Amended Statement of Environmental Effects for the development modification clause 4.55 DA
2019/1310

The address of the development is Lot C DP 302957 107 Griffiths Street Balgowlah

Proposed development; Demolition works, construction of attached dual occupancy and subdivision.

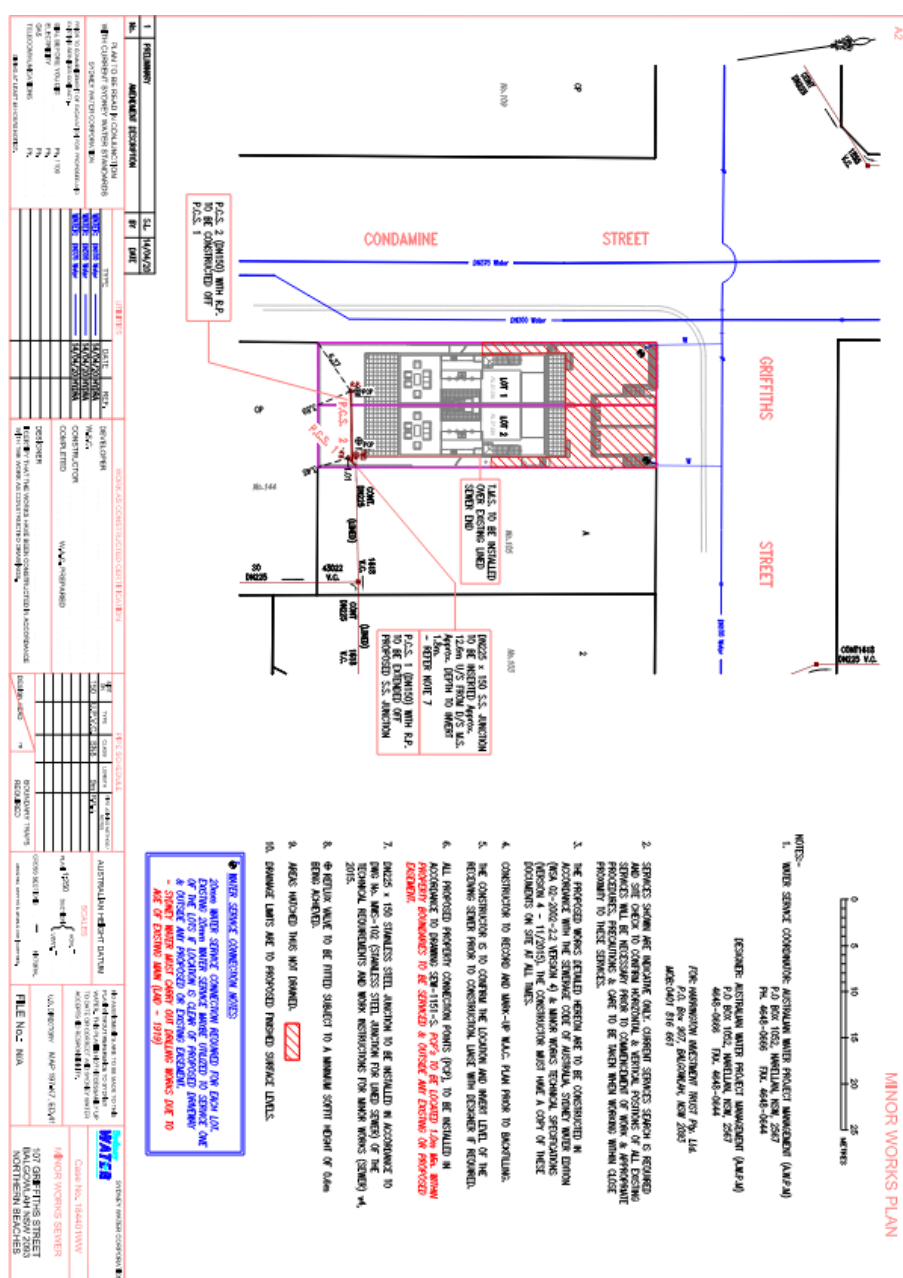
Condition no 1 – a) approved plans

Condition 22 (c) – Survey certificate – at the completion of the roof frame confirming the finished roof/ridge height is in accordance with the levels indicated on the approved plans.

As part of the Construction certificate application the plans were amended to incorporate the changes and the RL's of the slab was raised from the approved drawings in the condition 1 of the approval. The amendment of the RL's are as follows;

GF Approved RL 26.990 CC drawings approved by the certifier RL 27.238

First Floor RL 30.090 CC drawings approved by the certifier RL 30.338

Upper roof RL 34.140 CC drawings approved by the certifier RL 34.338

Survey Report

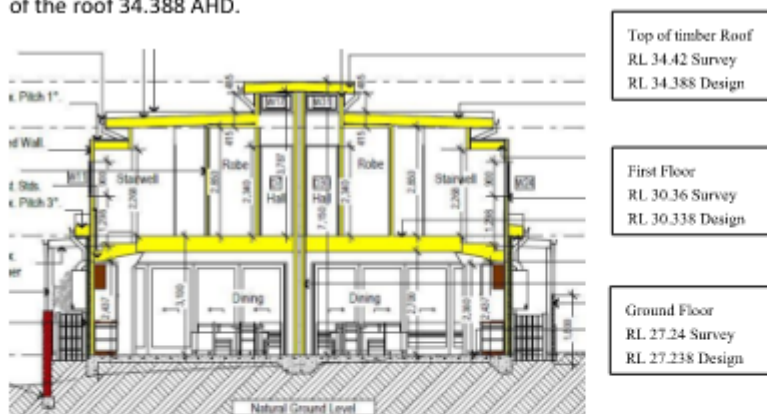
Adopting PM 990, having an RL of 24.826 AHD, we find the level of the Ground floor to be 27.24 AHD and the First floor level to be 30.36 AHD. We also find that the top of timber frame for Roof to be 34.42 AHD.

Design plans by Rapid Plans show the Ground floor level 27.238 AHD, First floor level 30.338 AHD and the top of the roof 34.388 AHD.
